Wisconsin Department of Transportation

Proposal #16: 1320-03-72, WISC 2020 537
Durand Ave, Village of Yorkville
67th Dr to 56th Rd
STH 11
Racine County

Letting of November 10, 2020

This is Addendum No. 01, which provides for the following:

Addendum No. 01
 ID 1320-03-72
 Added Sheet 12A
 October 21, 2020

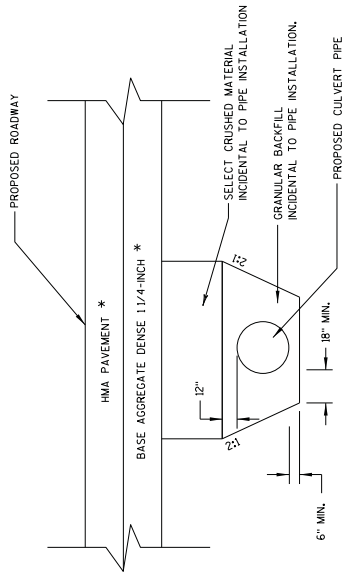
Added Plan Sheets	
Plan Sheet	Plan Sheet Title (brief description of why sheet was added)
12A	Construction Details (added culvert pipe replacement west of 67 th Drive)

APRON ENDWALL AND PARTIAL PIPE REPLACEMENT WEST OF 67TH DRIVE

* PAVEMENT STRUCTURE TO MATCH EXISTING.
 DEPTHS ASSUMED TO BE 6" HMA OVER
 12" BASE AGGREGATE DENSE 1 1/4-INCH

Addendum No. 01
 ID 1320-03-72
 Revised Sheet 13
 October 21, 2020

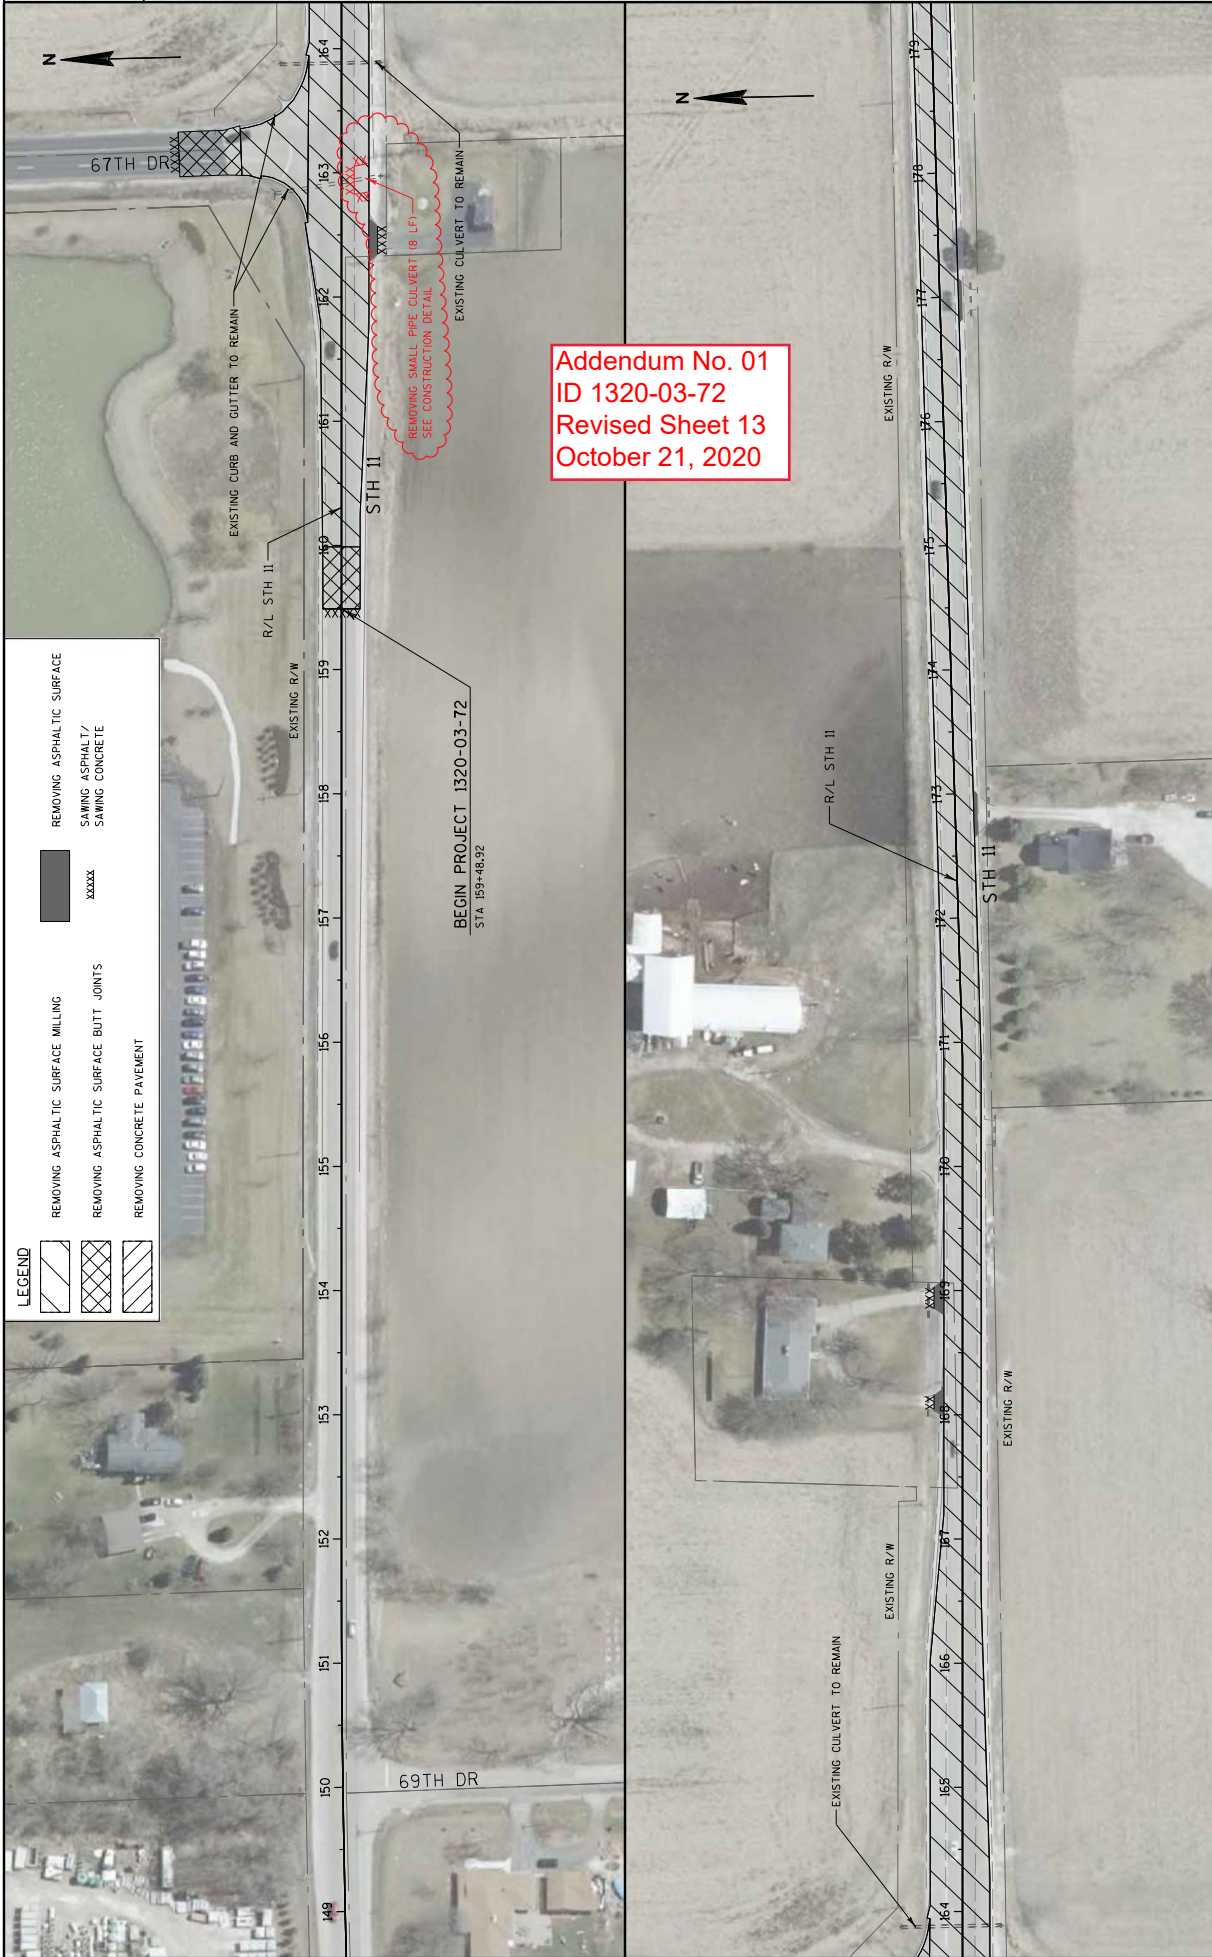
Revised Plan Sheets	
Plan Sheet	Plan Sheet Title (brief description of changes to sheet)
3	General Notes and Utility Contracts (updated Racine County – DPW contact info)
13	Removal Plan (added removal information at 67 th Drive)
15	Removal Plan (added endwall removal information)
16	Removal Plan (added endwall removal information)
57	Traffic control (updated legend, added sign and temp marking)
58	Traffic control (updated legend)
59	Traffic control (updated legend, added roadway labels)
60	Detour Plan (added signs 23, 24 & 25)
66	Miscellaneous quantities (added 'Apron Endwall Replacement' table)
